GJS Plot F, Manchester

Non-material Amendment | 10.07.2024

Z1-SHP-A180-RP-XX-NMA02 | P01

Updated proposal - Z1-SHP-G100-PL-B2-B5D801 - P02

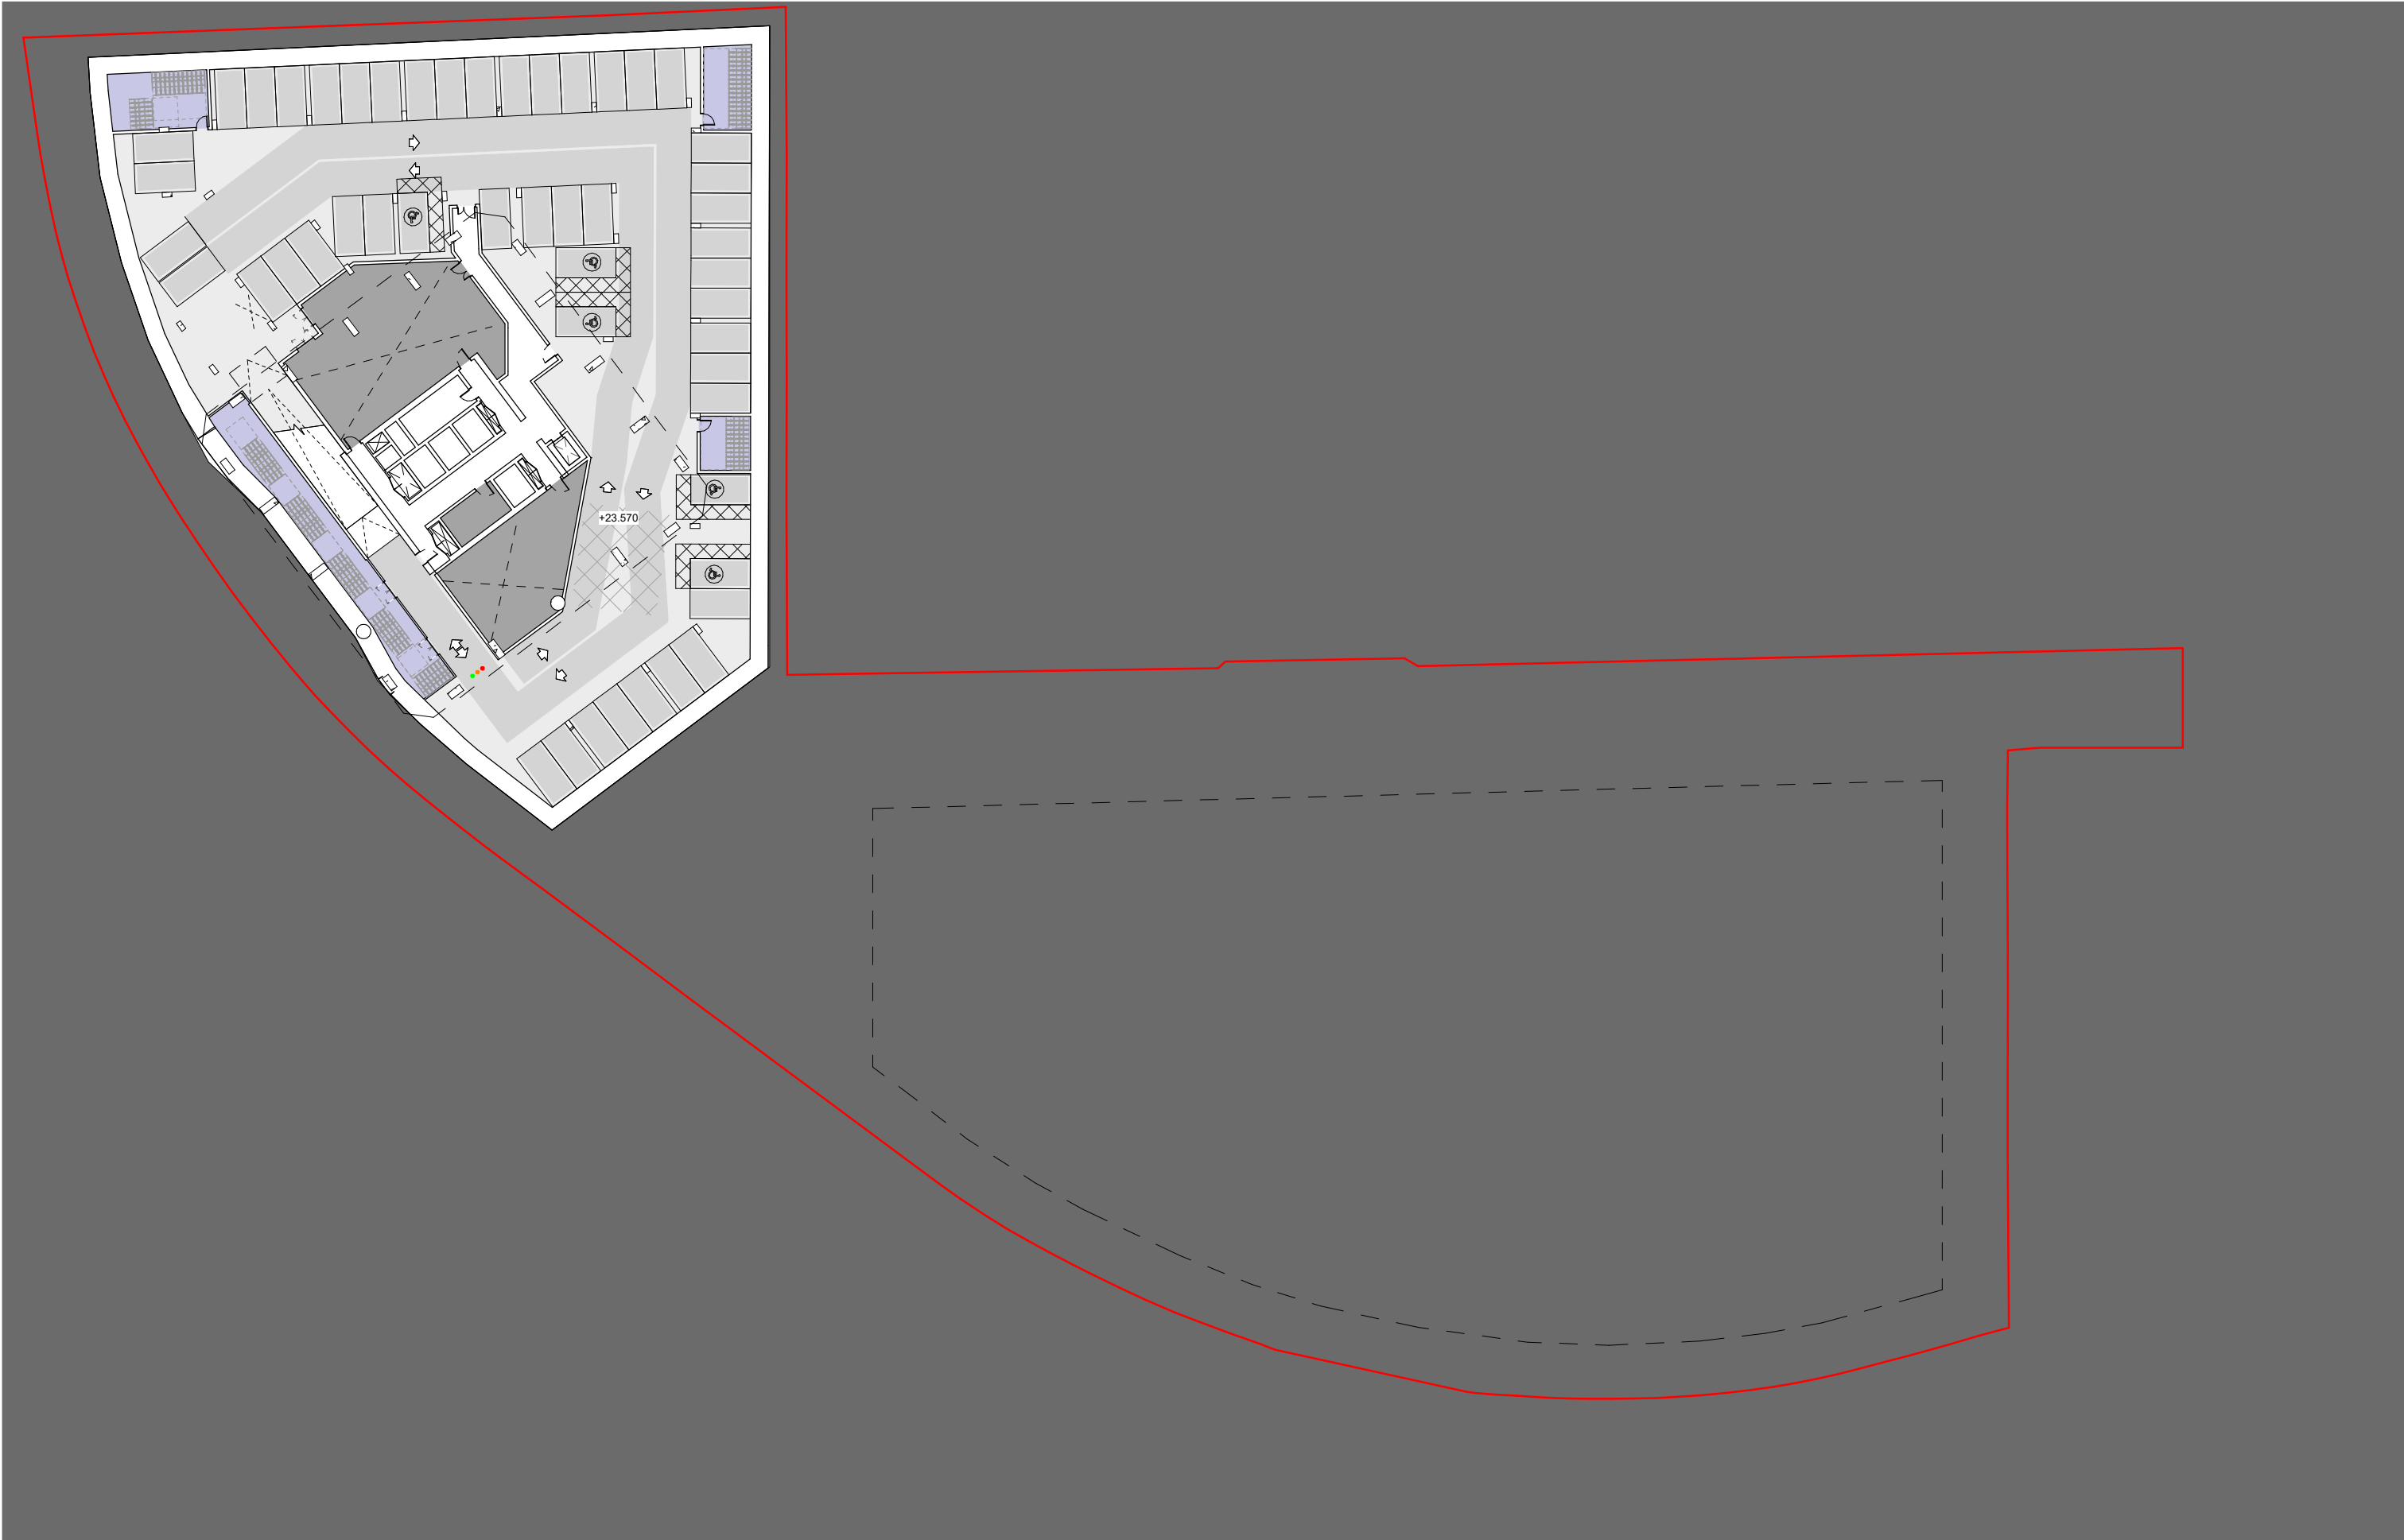
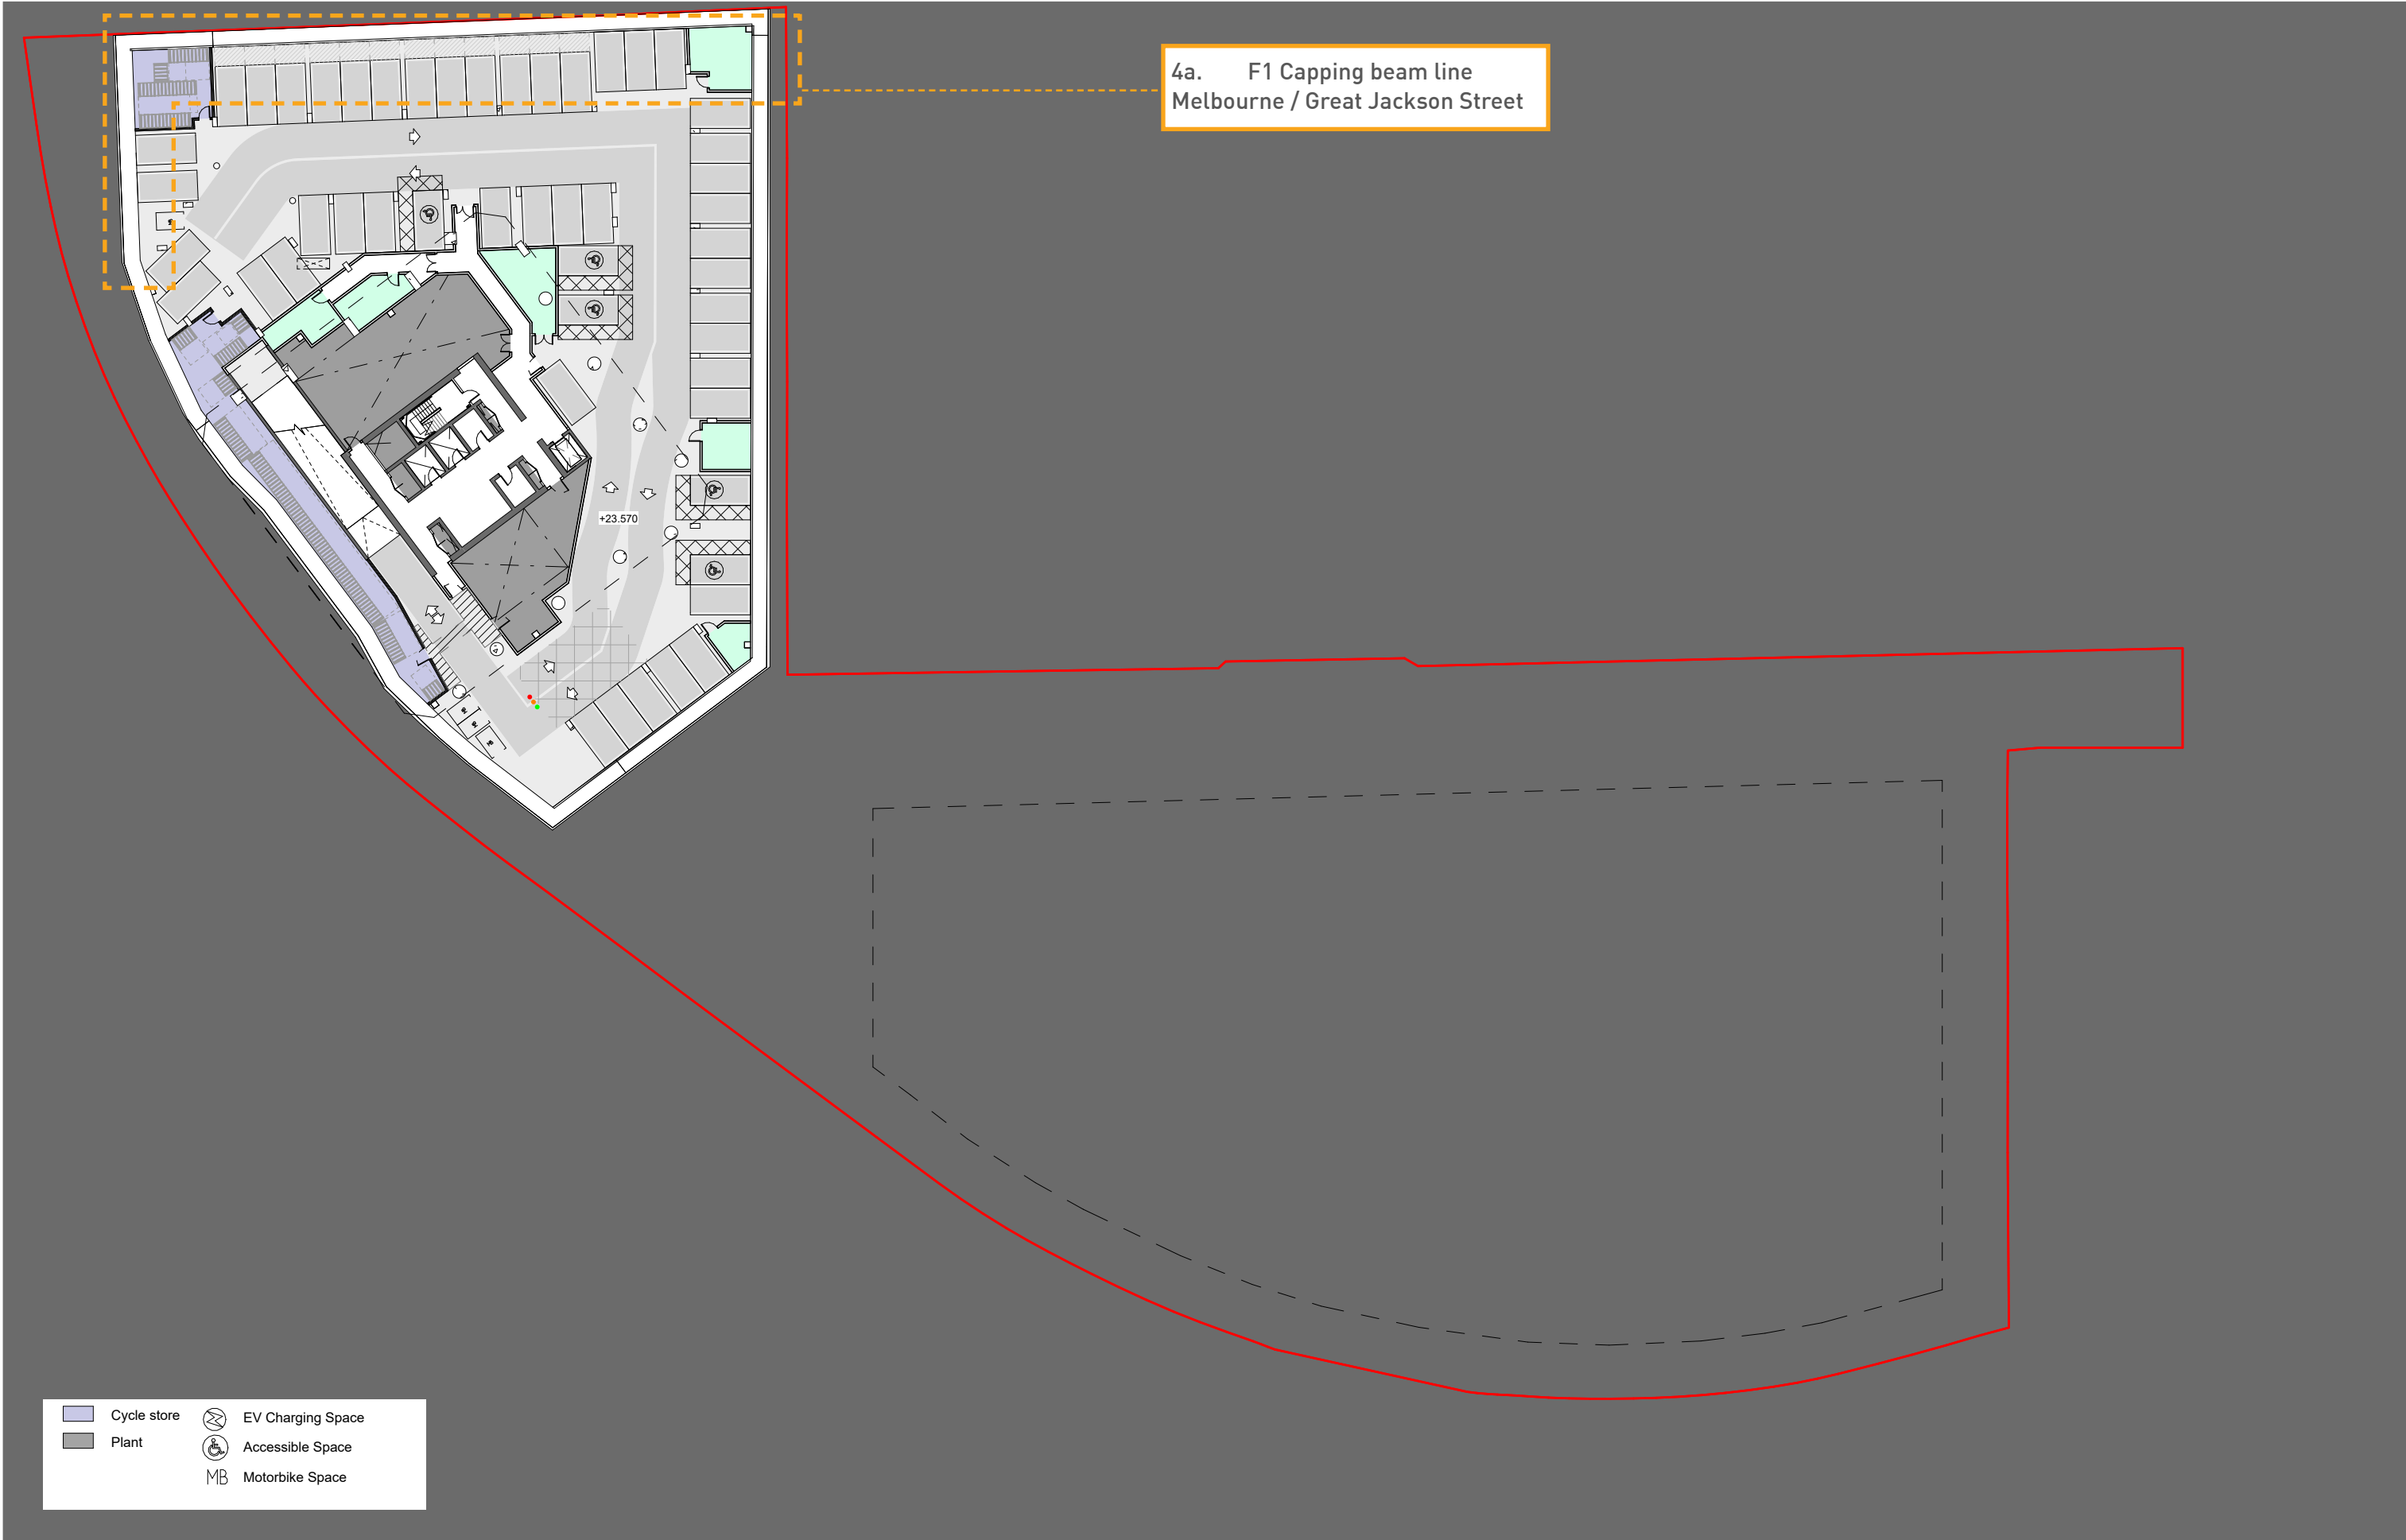
F1 Basement updates
 - a. **F1 Capping beam line Melbourne / Great Jackson Street**
The alignment of the capping beam for the F1 basement running down Melbourne Street has also been amended to tie in with the Crown Street Phase 3 application.

The revised arrangement reflects the applicant’s updated land ownership and allows for construction efficiencies within the back to back basement design.
